STATE OF MAINE
DEPARTMENT OF TRANSPORTATION
16 STATE HOUSE STATION
AUGUSTA, MAINE 04333-0016

March 17, 2026
Subject: Highway Rehabilitation &
Drainage Improvements
WIN: 026958.00
Location: **China & Vassalboro**
Amendment No. 2

CROSS SLOPE SHEET

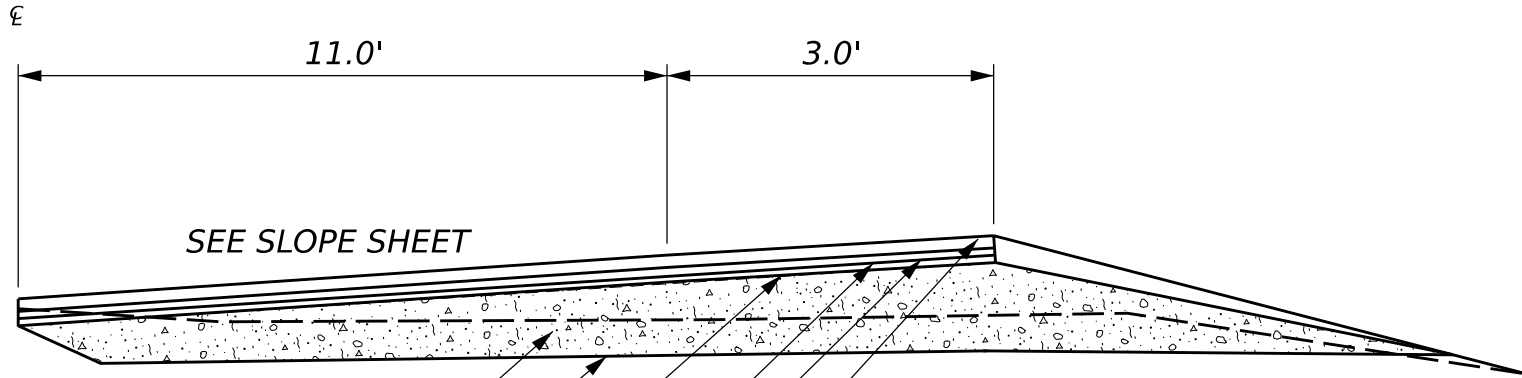
Remove Pages forty through forty one titled CROSS SLOPE SHEET dated September 19,2025 and **Replace** with the attached CROSS SLOPE SHEET dated March 10, 2026

Question: Construction notes and slope sheet calculations for the edge of the 11' travel way show numerous areas with cut depths over 6" and a lot approximately 7.5" to 9" to achieve desired slopes while maintaining a 2" CL cut depth.

- a. Does the department have data verifying sufficient pavement depths for the existing edge of travel way pavement thickness for these cut depths or existing slope conditions?
- b. If pavement depths are not sufficient or gravel is encountered when achieving the desired cross slopes how will the rehabs or mainline be paid?
- c. Will additional contract time be added if gravel is encountered on mainline milling?

Response: Please see updated schedule of items and slope sheets for this project

a. Does the department have data verifying sufficient pavement depths for the existing edge of travel way pavement thickness for these cut depths or existing slope conditions?

1. The Department has data available that may be provided to the Contractor after project award for planning purposes only.

b. If pavement depths are not sufficient or gravel is encountered when achieving the desired

cross slopes how will the rehabs or mainline be paid?

1. Where gravel is encountered, or where the existing pavement is found to be thin, the Department may utilize contract items for removal and rebasing as identified in the Construction Notes.

c. Will additional contract time be added if gravel is encountered on mainline milling?

1. If areas not identified in the Construction Notes are encountered, the Department will consider additional contract time based on the scope of the work required.
